# Technical Memorandum

**Re:** Spring Creek Hydrology Review

## Technical Memorandum

**To:** Della Schall Young, Young Environmental Consulting Group  
**From:** Jeff Weiss and Kallie Doeden, Barr Engineering  
**Subject:** Spring Creek Assessment Summary  
**Date:** September 6, 2019  
**Project:** 23101028.05

SPRING CREEK [CITY OF CARVER]  
404 BROADWAY ST.  
CARVER, MN 55315

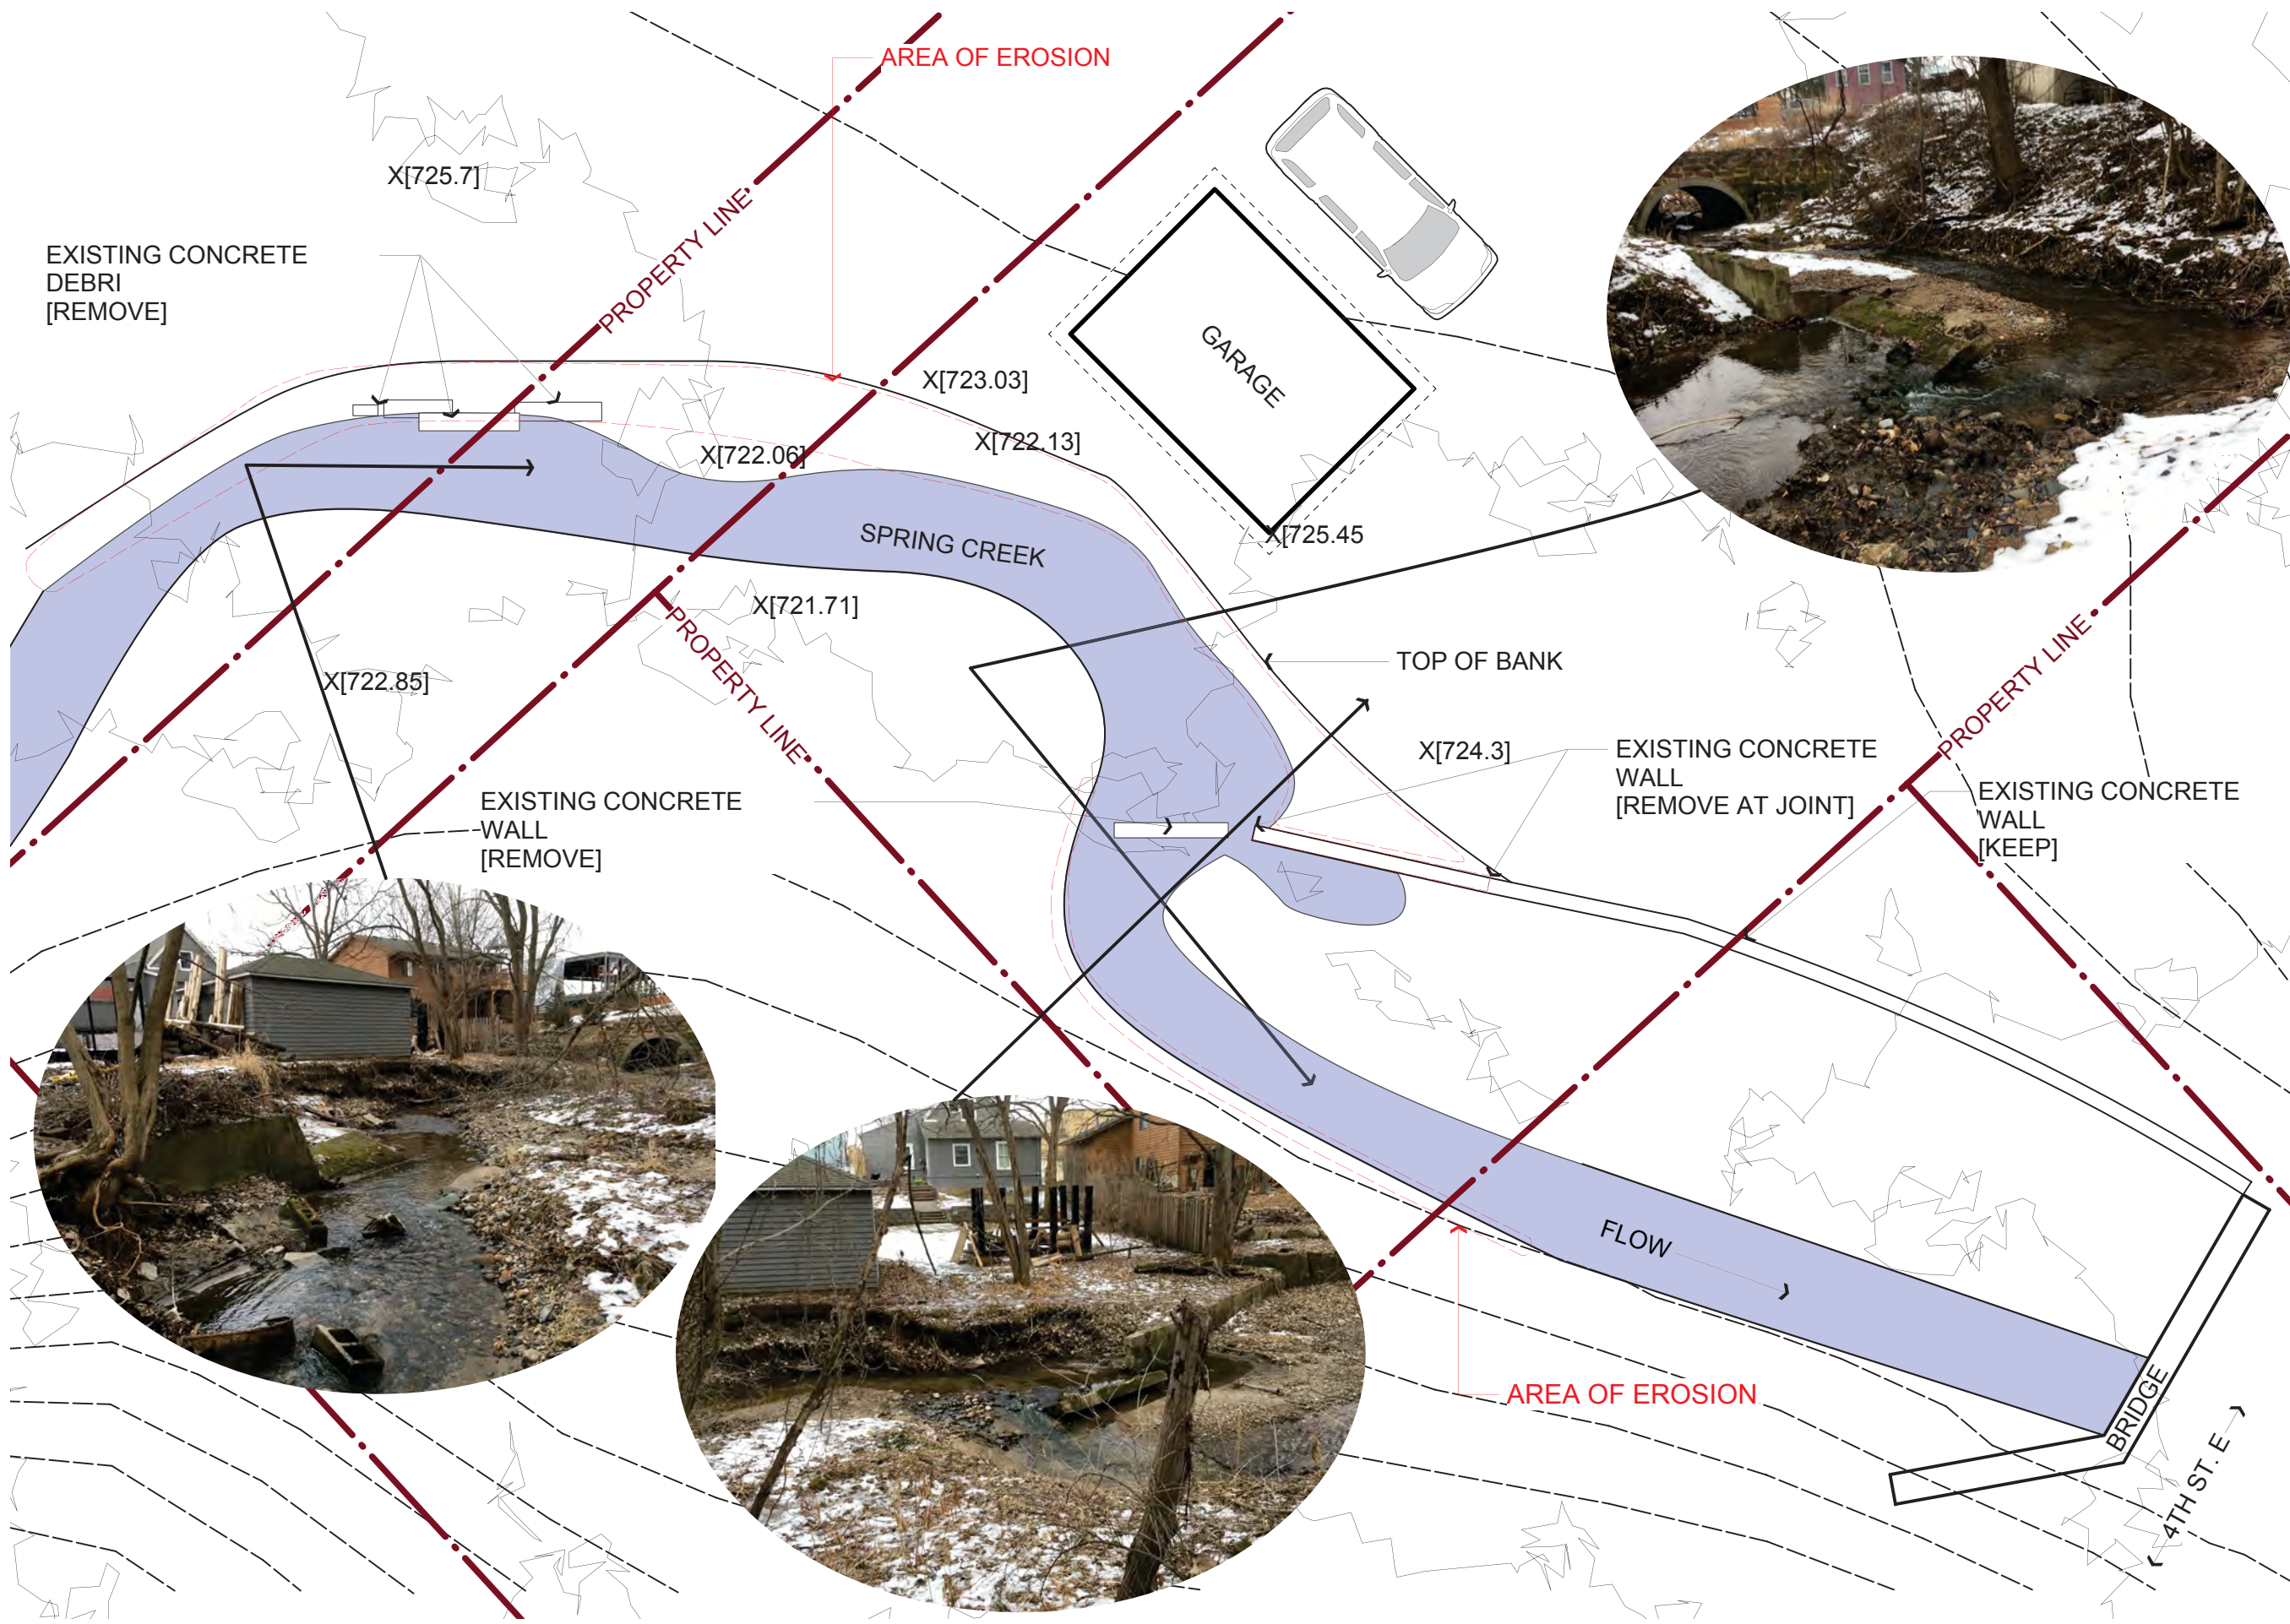
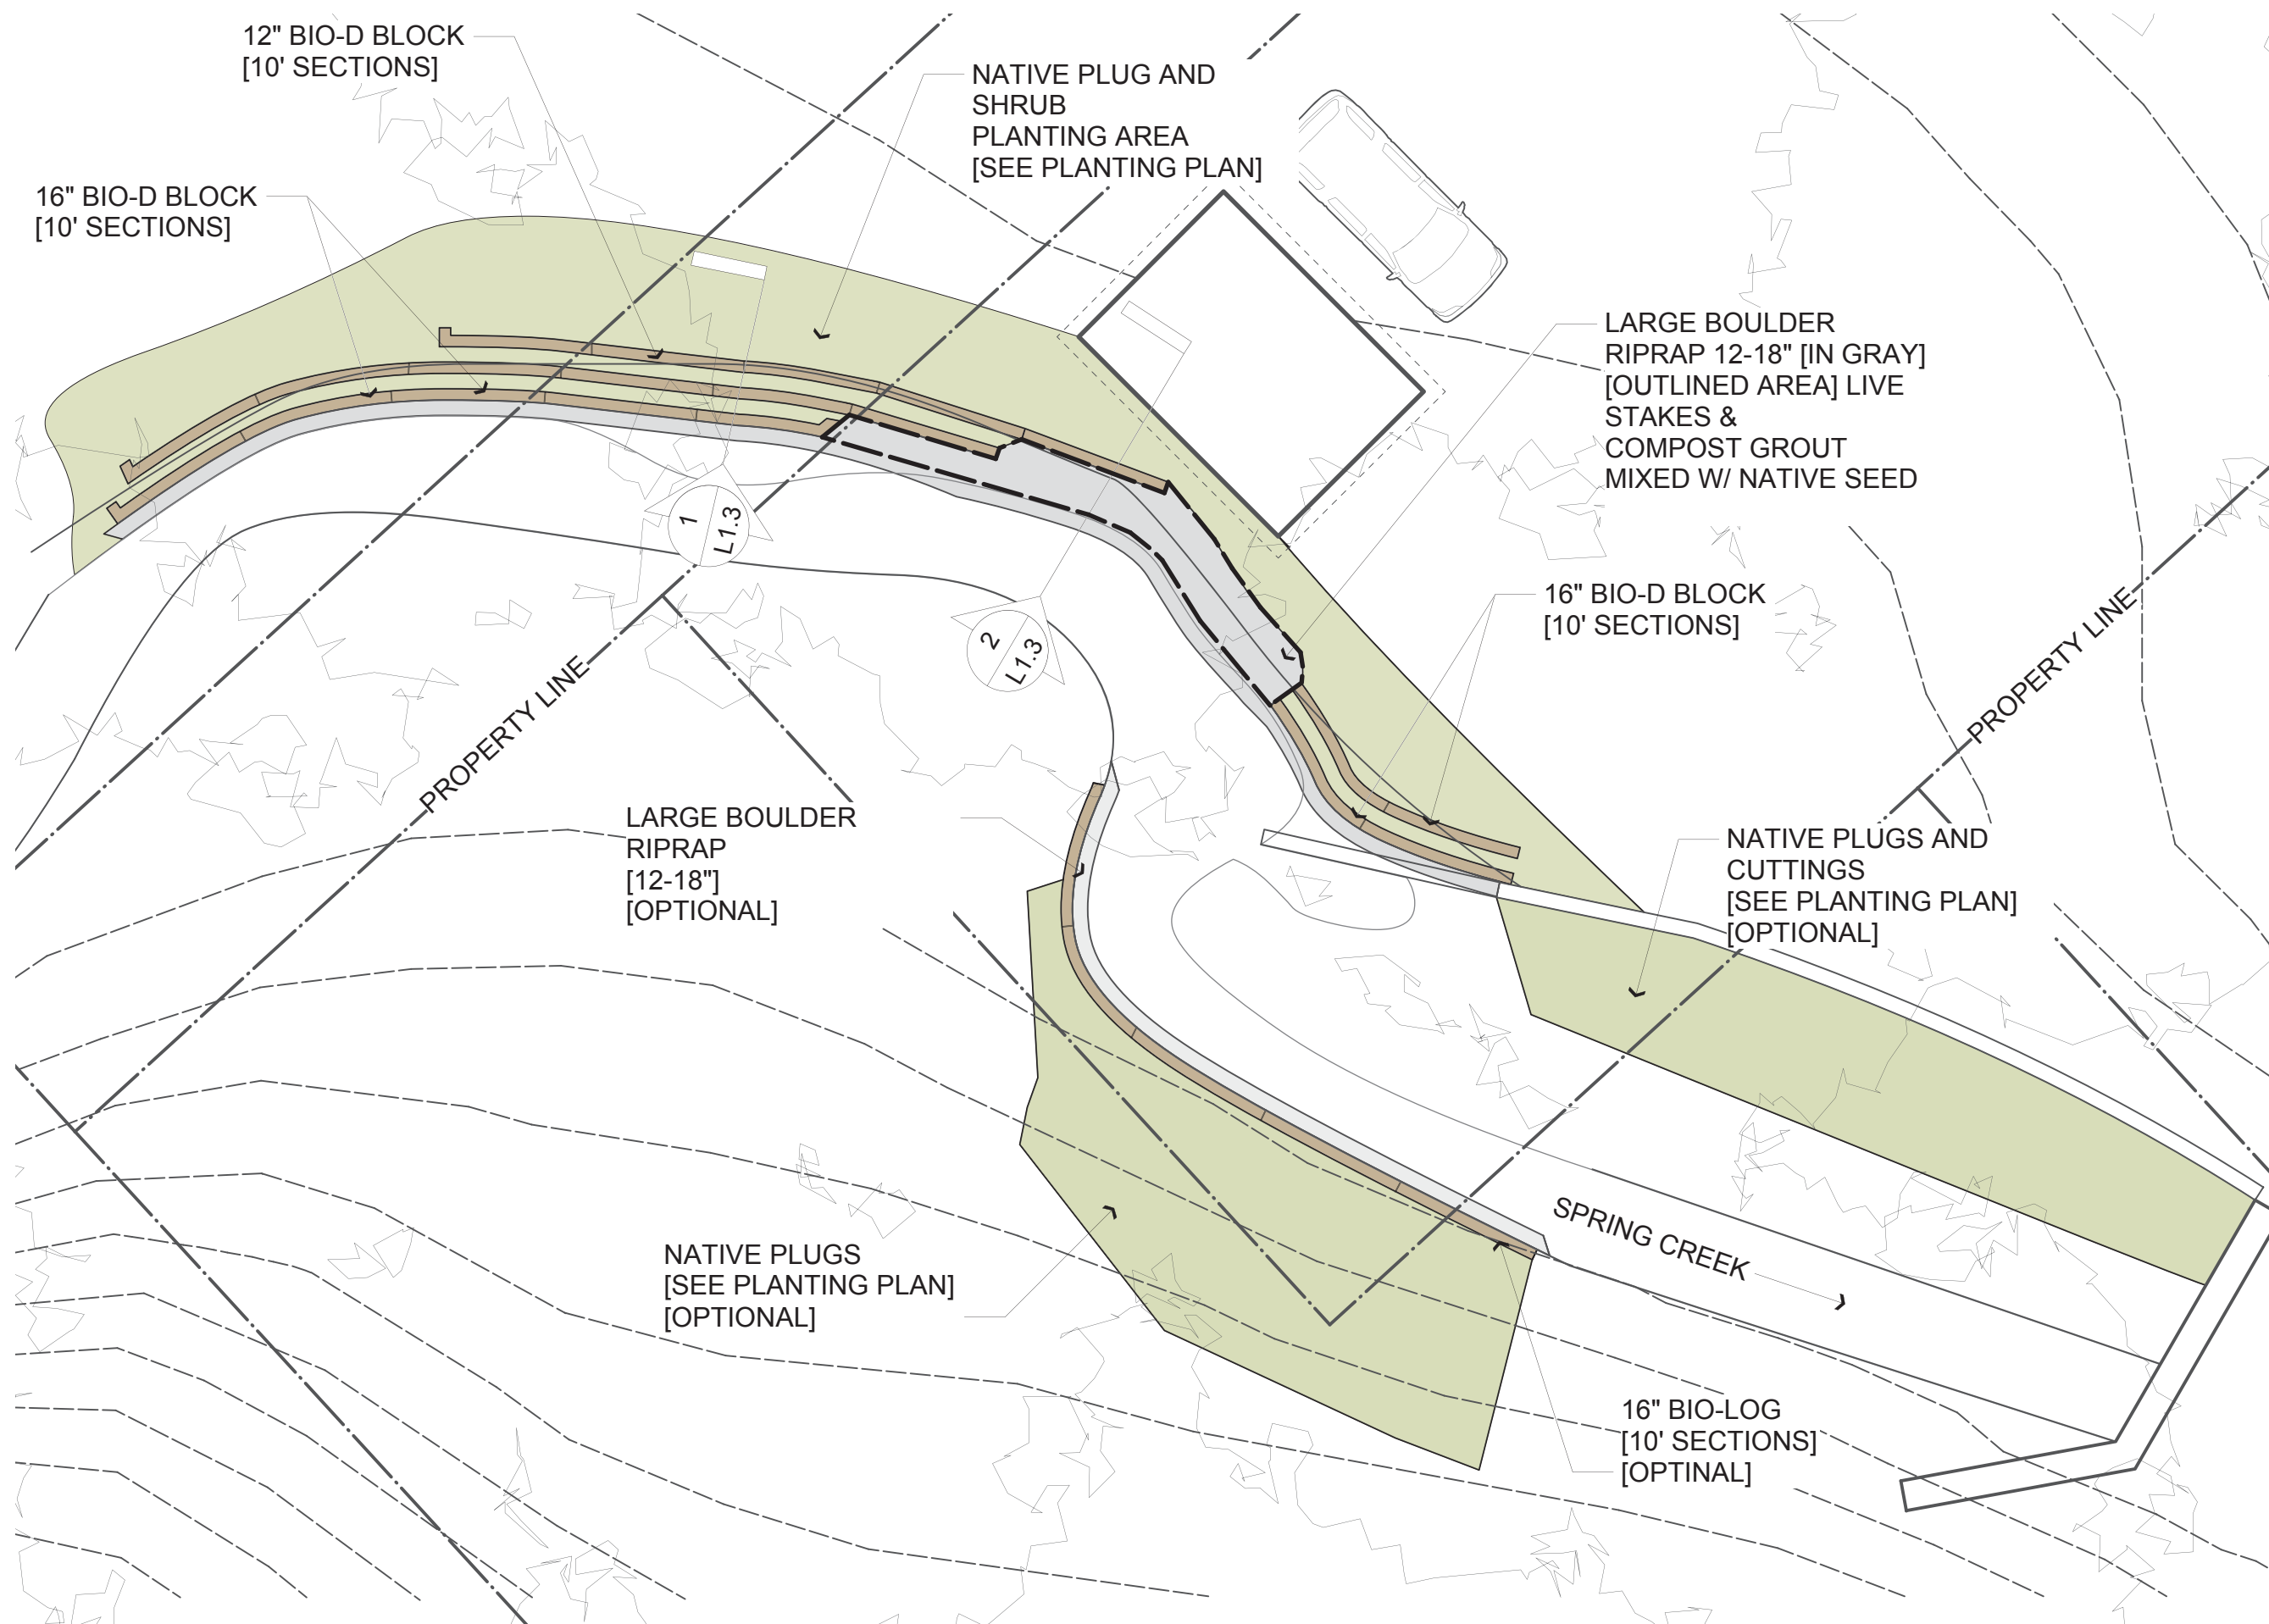
The Carver SWCD concept plan includes using riprap to armor the channel where banks are eroding, installing coir blocks in other areas with less stress, and revegetating with deep rooted species. Barr concurs with the general concept with the following considerations:

- At 404 Broadway, restore the channel to the previous alignment, which will provide additional space between the garage and the creek.
- Restore the previous channel alignment at 112 5<sup>th</sup> Street, with consideration of the modified hydrology draining to this location.
